Model: DW2000/3000	Apr. 6, 2018
Serial #: 002-109	
Product Bulletin # DW-011

Upgrading the Drawworks Encoder Cover to a Water-Resistant Encoder Cover

Figure 1: Current Design, Motor Encoder

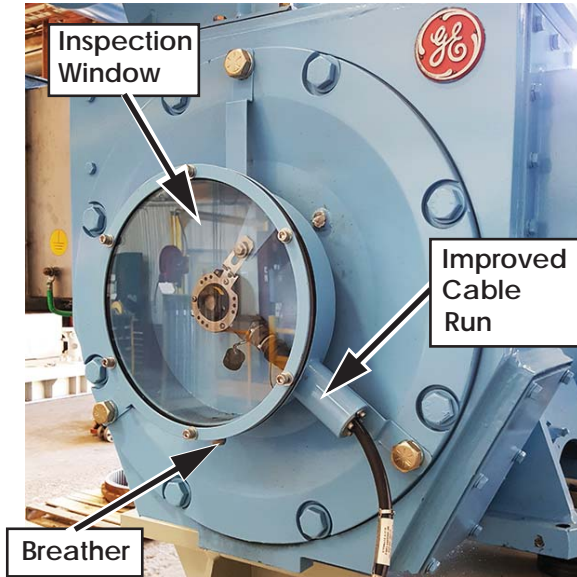
Pressure washing the drawworks can cause encoder malfunction. CANRIG has developed an enclosed, water-resistant encoder cover designed to improve encoder protection against water ingress.

Field kits are now available for upgrade. Field Kits depend upon the type of motor on the drawworks. Refer to Table 1. Kits include two (2) encoder covers for the motor, and one (1) encoder cover for the drum.
